ACER Decision on the ERAA 2021: Annex I

DECISION No 02/2022
OF THE EUROPEAN UNION AGENCY
FOR THE COOPERATION OF ENERGY REGULATORS
on the European Resource Adequacy Assessment for 2021
Technical annex

22 February 2022

Figure 1: Charging profiles for electric passenger cars - assumptions from ENTSO-E and selected countries (percentage of daily charging)

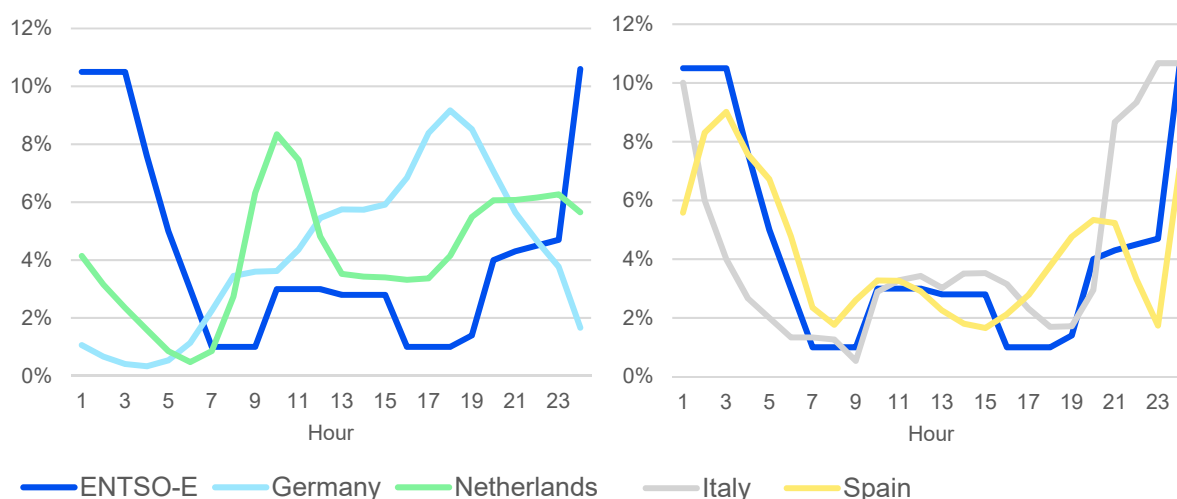
Figure 1 points to some similarities and differences across the different passenger electric vehicle charging profiles. For the majority of Member States, the bulk of charging is assumed to occur in the evening and night hours (possibly associated with home and off-street charging) and during office hours (possibly associated with workplace charging). In the vast majority of cases, some electric vehicle

Figure 2: DSR potentials per cost band and as a share of total DSR potential for EU-27 - 2025 assumptions

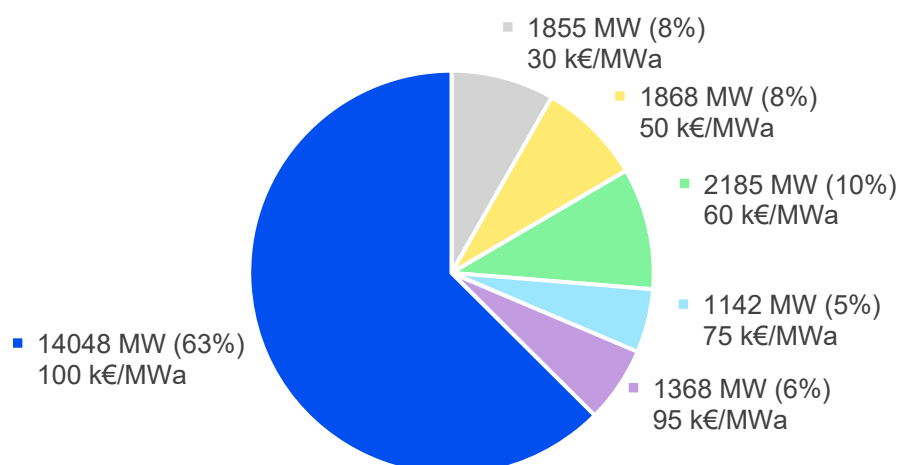
Figure 2 presents the additional DSR potential per cost band across the EU-27, in terms of capacity and as a share of the total DSR potential. The graphs show that the largest share of the additional DSR potential, around 63%, is allocated to the highest cost band. ACER understands that this band relates to DSR potential in the commercial sector. On the other hand, the potential for low-cost DSR (bands with annual costs of 30 and 50 k€/MWa) is limited to less than 4 GW, or 16% of the total DSR potential. Essentially, the ERAA 2021 implicitly assumes that the low-cost DSR potential is largely exploited through the exogenously determined assumptions. The assessment does not provide any evidence for it. Moreover, the total costs of the highest-cost DSR band are higher than the equivalent costs for Open-Cycle Gas Turbine (OCGT) power plants, making this DSR potential uneconomic in any event.²⁴ In other words, the model would never invest in this DSR potential, as OCGT power plants would always be more economic in the model.

It is therefore questionable why the ERAA 2021 utilises the ADEME study to assess the economic potential of DSR in Germany, instead of the detailed German study undertaken for this purpose. As a minimum, ACER would have expected the assessment to use detailed national studies where these are available.

Figure 3: Difference in assumed installed wind and solar generation capacity assumed in the National Energy and Climate Plans compared to the ERAA 2021 – 2025 (GW)

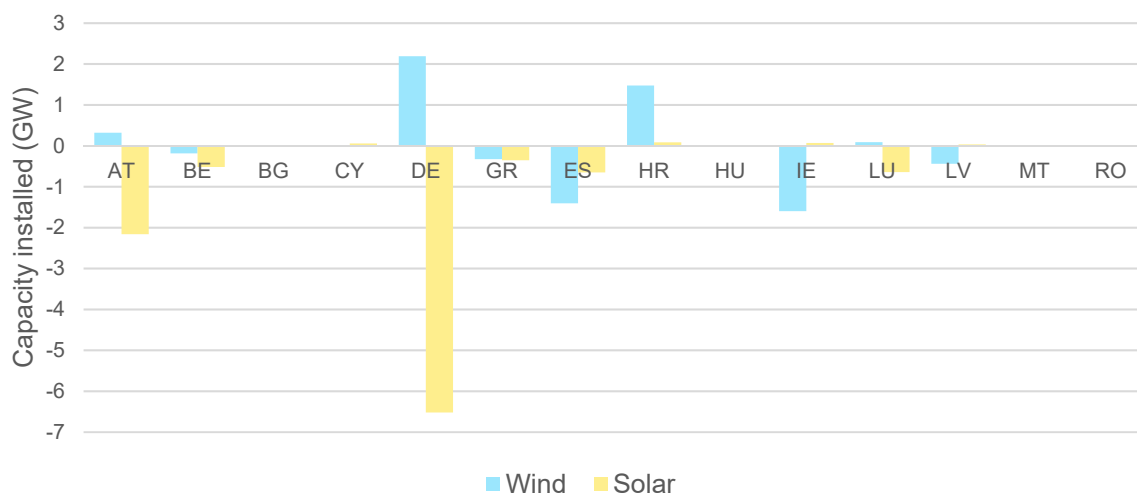
ACER compared the ERAA scenario assumptions for renewable generation with the NECPs. The comparison focuses on wind and solar, which are assumed to be policy related assets in the ERAA 2021 (i.e. subject to targets by Member States and not market-driven). The comparison focuses on the so-called "With Additional Measures" scenario of the NECPs that represents a scenario meeting the 40% emissions reduction target.⁴⁰ ACER could analyse 14 Member States due to limited, readily available data. Figure 3 presents the results of this analysis, i.e. the differences in projected installed capacity for wind and solar generation between the NECPs and ENTSO-E's assumptions for 2025. Overall, ENTSO-E's scenarios project a lower installed capacity of over 10 GW. The total difference is

driven by lower installed capacity for solar generation, while the overall figure for wind is similar between the NECPs and ENTSO-E’s scenarios. The analysis also shows variations within Member States. ACER notes that these differences are relatively small compared to the total installed capacity of wind and solar.

Figure 4: Differences in installed generation capacity between Summer Outlook 2021 and National Estimate scenario – 2021 and 2025 assumptions, respectively (GW)

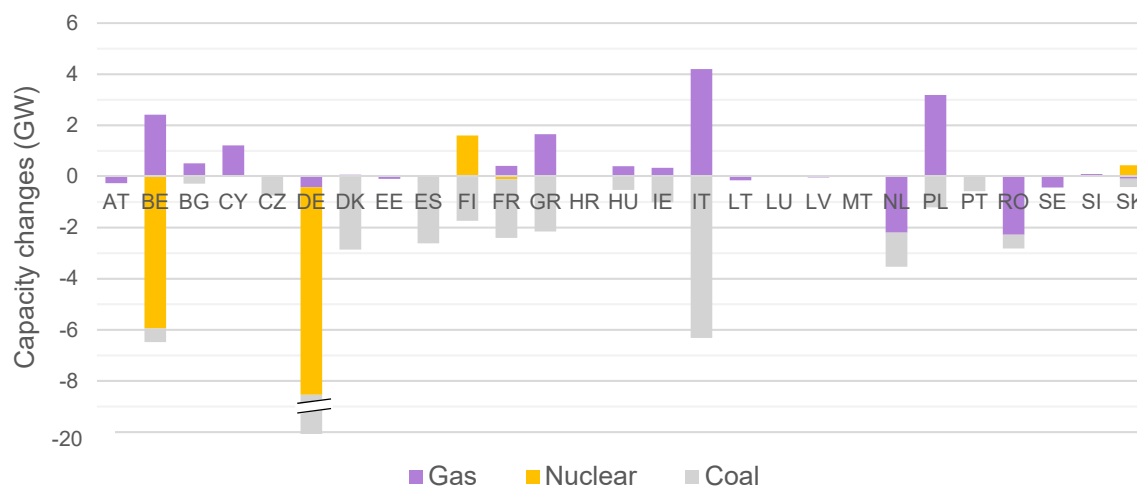
In addition, ACER has analysed the differences in thermal capacity between today and the ERAA 2021 assumptions for 2025. To perform this comparison, ACER has used the assumed installed capacity in the Summer Outlook 2021 as the most reliable source of currently installed capacity.⁴¹ We compare these installed capacities with the assumptions under the National Estimates scenario drawn by the TSOs, as this largely reflects any known phase-out decisions and development of new plants.⁴² The analysis shows that around 67.5 GW of thermal capacity are expected to shut down between today and 2025, while around 16.5 GW are added in the same period.⁴³ Figure 4 presents the changes in installed capacity between today and the 2025 assumptions of the National Estimates scenarios for natural gas, nuclear, coal and lignite generation. The total amount of closures and additions for these technologies amount to 56.4 GW and 16.5 GW, respectively.⁴⁴

Figure 5: Assumed forced outage rates for gas technologies across EU-27 bidding zones - 2025 (percentage)

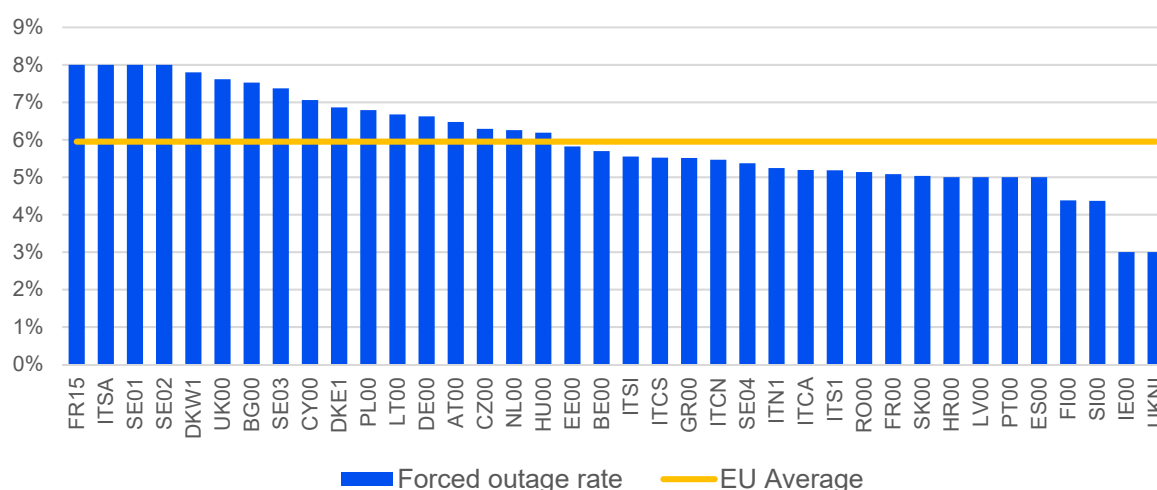
Figure 5 presents the weighted unplanned outage rate for gas generation, for each bidding zone in EU-27 and the average across the whole of EU-27 (orange line). Gas generation will form the bulk of thermal generation in the future, as several Member States gradually phase-out other thermal generation, such as more polluting coal-fired and lignite-fired power plants, or thermal capacities retire due to unfavourable economics. The figure shows that forced outage rates vary across EU-27 from 3% - 8%, with an average of around 6% across the region. While this range might appear narrow at face value, a 1% improvement in the forced outage rate is equivalent to an additional 2 GW of gas capacity on average across the peak hours. This means that a small change in the unplanned outage rate for gas generation has an appreciable impact on its available, average capacity and may subsequently affect the results of the assessment.

In relation to unplanned outages, ACER recommends that ENTSO-E investigates the impact of pricing signals and tighter markets on forced outage rates for gas technologies in particular (low priority). As explained above, gas-fired generation will represent the main form of thermal generation in the future. As the market disposes of current over-capacity and simultaneously market reforms progress to improve the functioning of the wholesale market (e.g. via the market reform plans developed by Member States pursuant to Article 20 of the Electricity Regulation), it is expected that the market signals for gas-fired power plants will improve. At the same time, current unplanned outage rates for these plants are

Figure 6: Assumed installed battery storage capacity in the EU-27 – 2025 (GW)

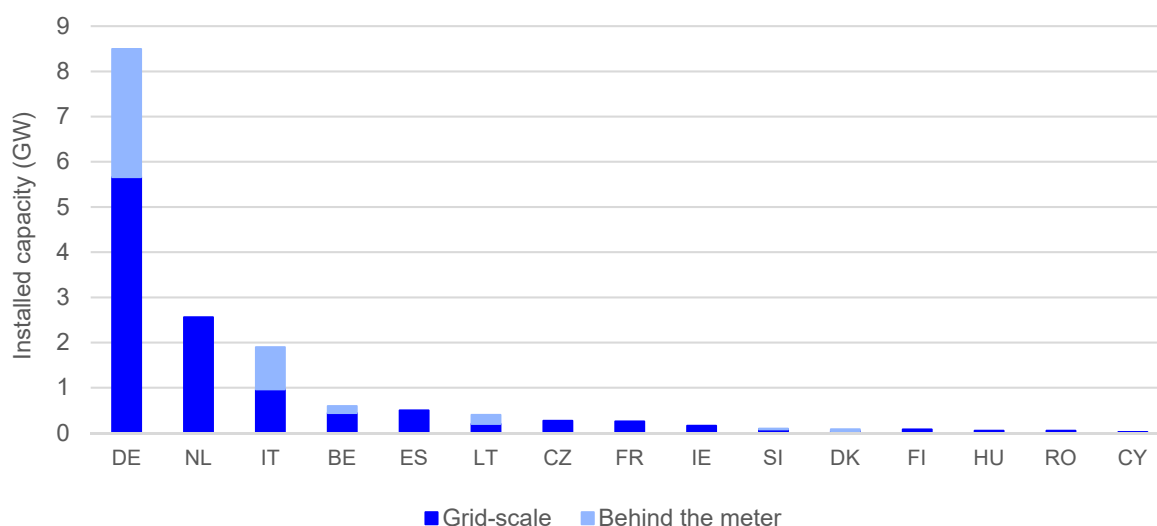
The description of the assumptions on battery storage is limited in the ERAA 2021. Importantly, the Report does not contain any information about the sources used to assess the projected levels of installed capacity. ACER understands that the assumptions on battery storage are based on national TSOs' forecasts. The Report does not provide information about how these forecasts are established, for example, whether they are based on market data (e.g. historical trends of installed batteries), projects currently in the pipeline, or other sources. Similarly, the Report does not specify how the rate of peak shaving associated with behind the meter storage is derived (e.g. how peak hours are defined for this purpose).

Figure 6 presents the assumed installed battery storage capacity per bidding zone in 2025. ACER observes that battery storage features in just over half of the Member States in EU-27, and for many of these Member States the assumed capacity is negligible. It is unclear from the Report what drives these significant differences across Member States (e.g. regulatory framework, support policies).

Figure 7: Average NTCs per border - 2020 (realised) and 2025 (ERAA 2021 assumptions) (MW)

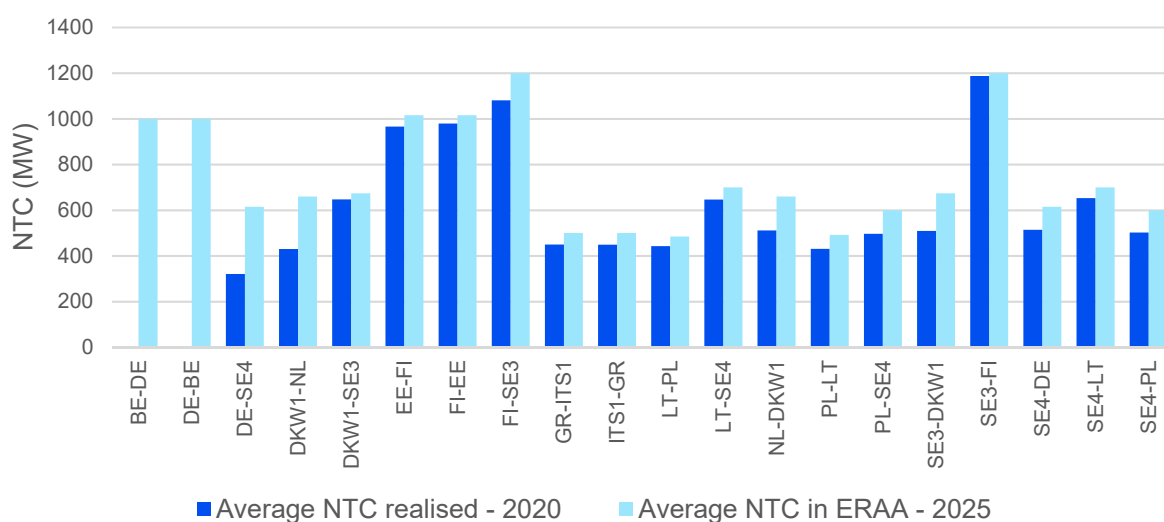
Figure 7 presents the average NTC value in 2020, and the average NTCs assumed for 2025 in the ERAA 2021, for each DC border.

Figure 8: ACER’s assessment of the 70% minimum target based on the ERAA 2021 NTC assumptions for 2025

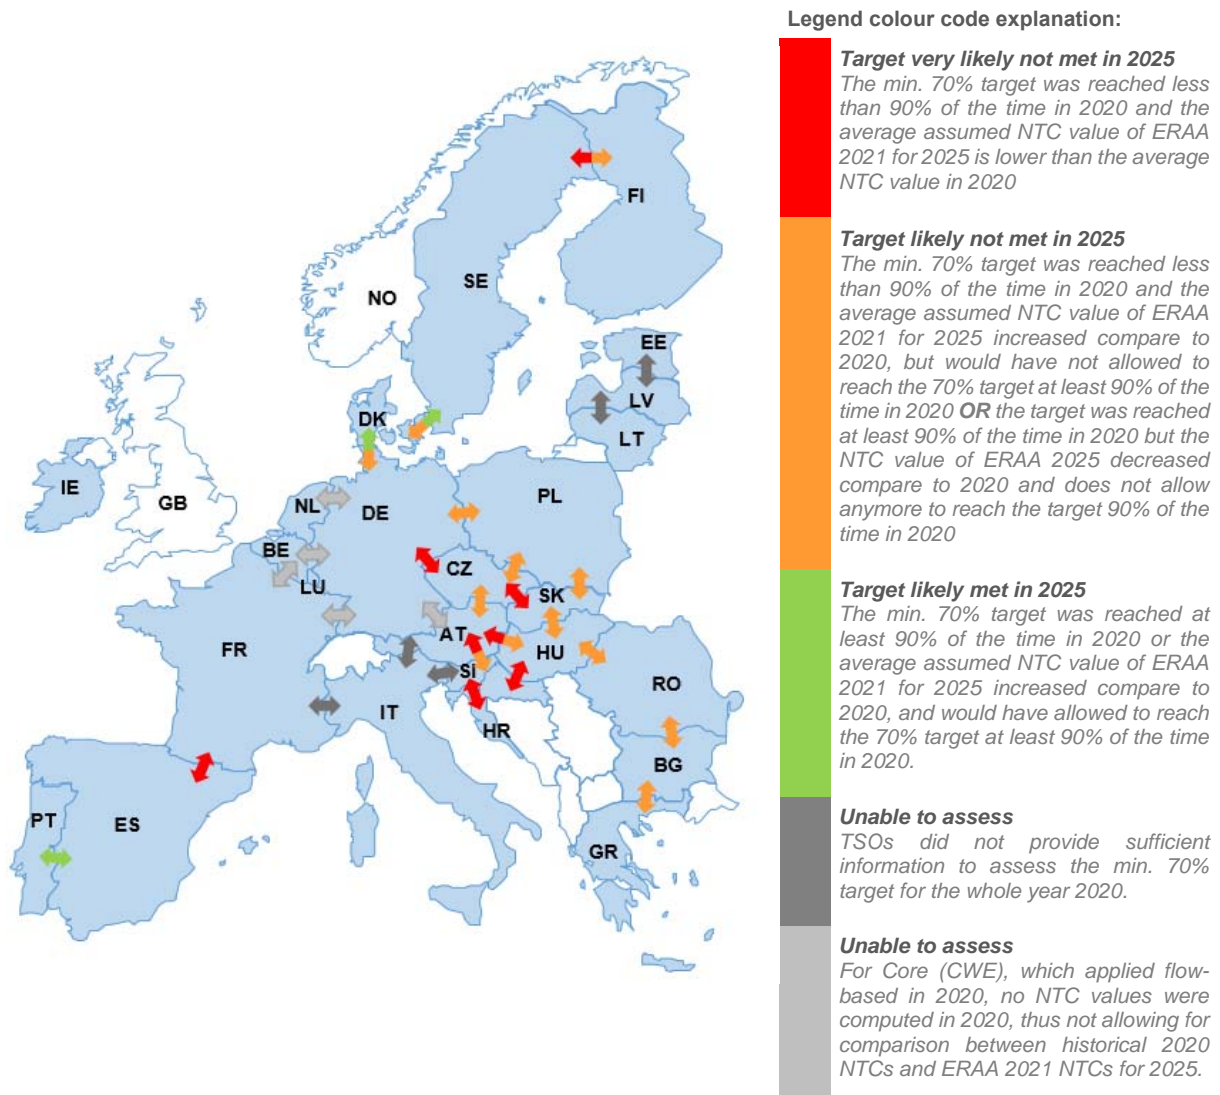
Figure 8 shows whether NTCs for 2025 of the ERAA could allow TSOs to meet the 70% minimum target for each AC border.

For Core (CWE), the NTCs in the ERAA 2021 have not increased compared to the values in MAF 2018. This would suggest that the NTCs of the ERAA 2021 model were not computed to meet the minimum 70% target. However, for Core, the ERAA 2021 asserts that this is the case (see subsection on Flow-based domains below).

Figure 9: Differences in FCR requirements per Member State – 2020-2025 (MW)

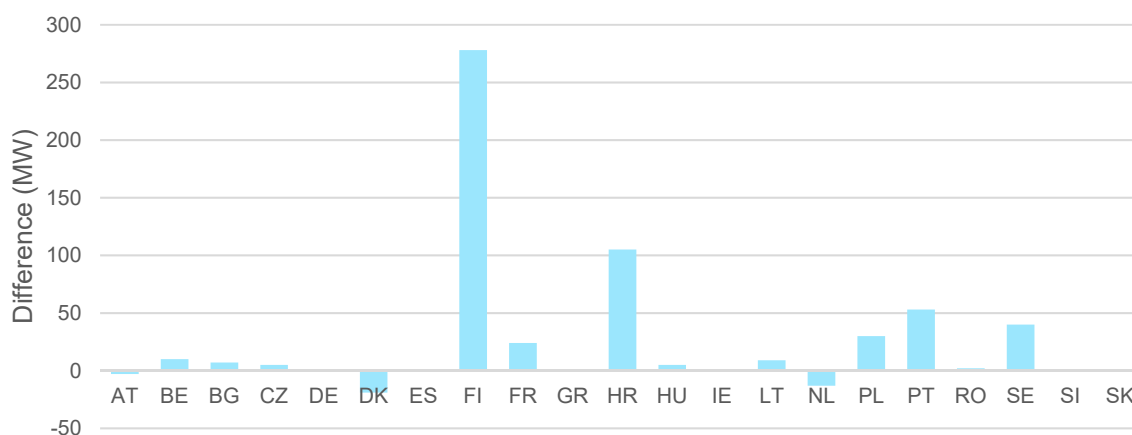
ACER has compared the ERAA 2021 assumptions for FCR and FRR requirements in 2025, with the actual 2020 requirements based on the volumes collected for ACER-CEER’s Marker Monitoring Report 2020 (ACER-CEER’s MMR 2020). Figure 9 presents the differences for the FCR requirements. The total requirement for FCR across the EU-27 increases to 4.6 GW compared to 3 GW currently. The graph shows that the requirements either increase or remain constant, while in limited cases the level of FCR reserves decreases slightly. In a couple of cases, FCR requirements increase significantly compared to current practices, notably for Finland (nearly 300 MW) and Croatia (just over 100 MW).

Future ERAAs would significantly benefit from clear explanation about the methodology used to determine reserve requirements and the main drivers for any changes compared to present (high priority).

Figure 10: Differences in assumed FCR requirements per Member State – 2020-2025 (MW)

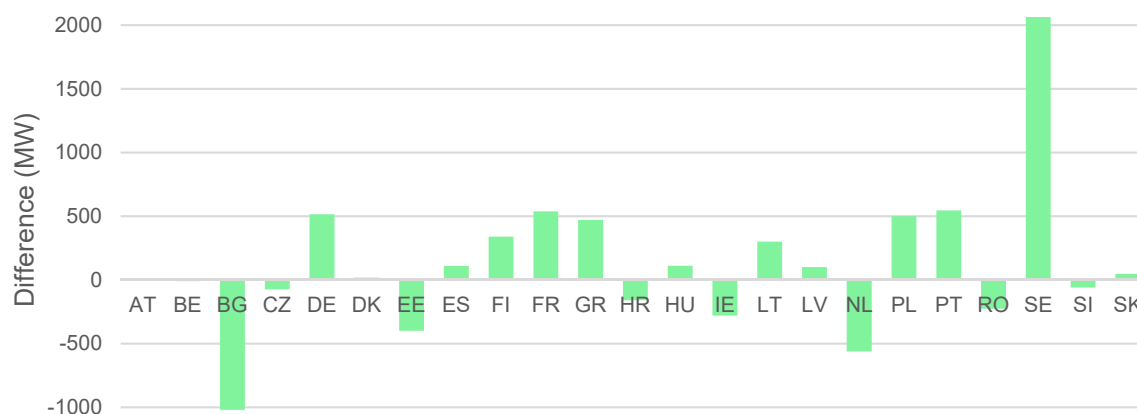
Similarly, Figure 10 presents the differences for the FRR requirements between the 2025 assumptions in the ERAA 2021 and the actual 2020 requirements, based on data collected for ACER-CEER’s MMR 2020. The picture is more mixed in this case. For the majority of bidding zones, the reserve requirement

increases. In several occasions, this increase is significant in absolute terms: around 500 MW for Germany, France, Greece, Poland and Portugal. For other bidding zones the increase is less pronounced (e.g. an increase of around 340 MW in Finland) or negligible. For a different group of bidding zones, the reserve requirement decreases compared to 2020. The reduction is more significant for Bulgaria (around 1000 MW) and the Netherlands (around 500 MW). Overall, the reserve requirement for FRR is projected to increase up to 28.2 GW in EU-27.

Figure 11. Comparison of the LOLE results between the economic dispatch (ERAA 2021 results) and the EVA model (central reference scenario without CM) – 2025 (hours per year)

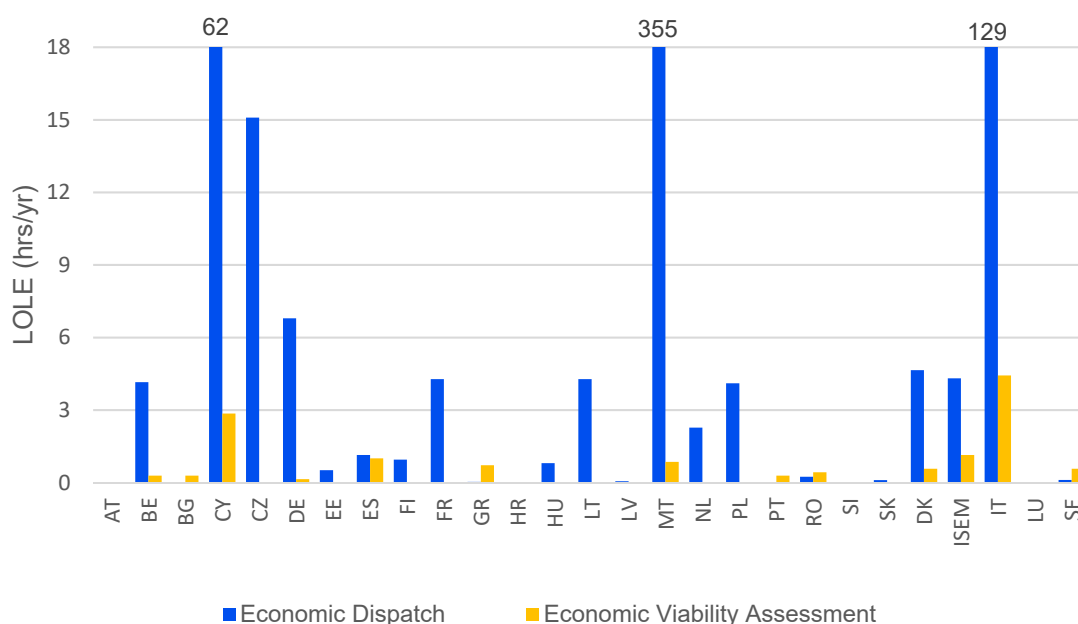
Article 6(6) and Article 6(9) of the ERAA methodology require that the EVA relies on the results of the economic dispatch to assess economic decisions. In this way consistency between the two models is ensured. A comparison between the loss of load expectation (LOLE) indicator from the EVA and economic dispatch, for the central reference scenario without CM, reveals significant differences between the two models (Figure 11). The expected energy not served (EENS) values of the EVA are zero or close to zero for almost all modelled zones, compared to the ERAA results that show non-zero EENS values in most modelled zones.⁶³ Hence, the ERAA 2021 does not provide an appropriate level of consistency between the EVA and economic dispatch, undermining the robustness of the approach followed and leading to dubious results.

As the EVA essentially determines the capacity resource mix that is available for serving demand, the implications of such an inconsistency are significant. ENTSO-E conducted a qualitative viability assessment of coal, gas, lignite and oil fired generation units based on the outcome of the economic dispatch model for the central reference scenario without CM.⁶⁴ The results indicate that in most cases resources are highly profitable, while in limited cases capacity is not profitable.⁶⁵ As an example, the examination of profitability of gas fired units, presented in Figure 12, shows that profits are several times higher than e.g. the fixed costs of existing gas units used in the model.⁶⁶ These profits are generally higher in modelled zones with high LOLE,⁶⁷ indicating that additional capacity can potentially reduce the adequacy risks without jeopardizing the viability of the existing units. Evidently, the EVA does not accurately capture the risks and opportunities of the economic dispatch market simulations. The results demonstrate an overall underestimation of the capacity resources that could have entered or remained in the market and thus an overestimation of the adequacy indicators.

Figure 12. Profitability of gas fired units based on expected revenues and costs from the economic dispatch results for the central reference scenario without CM – 2025 (€/kW)

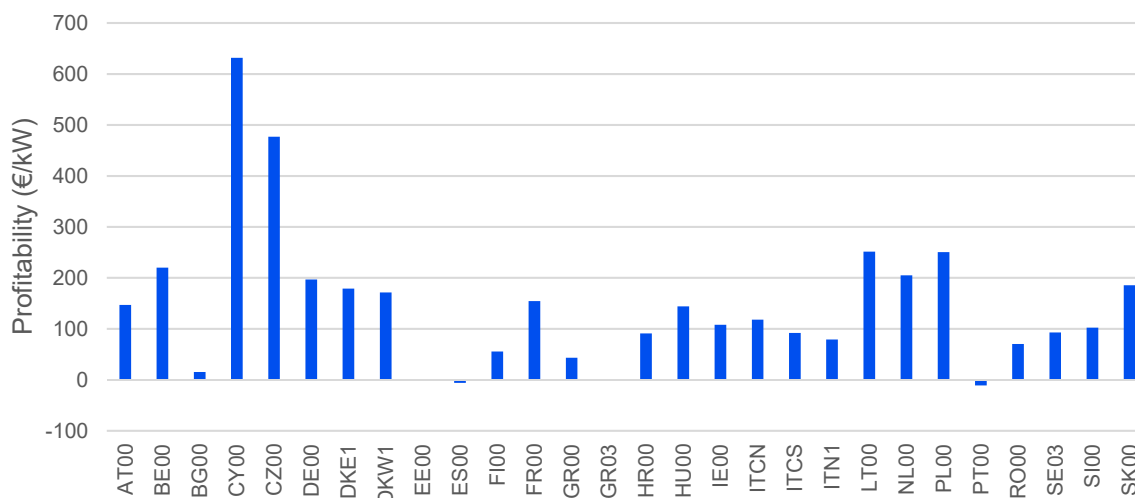
⁶⁷ As a characteristic example for Czech Republic profits of gas fired units reach 477 euros/kW, while at the same time LOLE is 15 hrs/year, and the EVA resulted in the economic decommissioning of 5GW of thermal units.
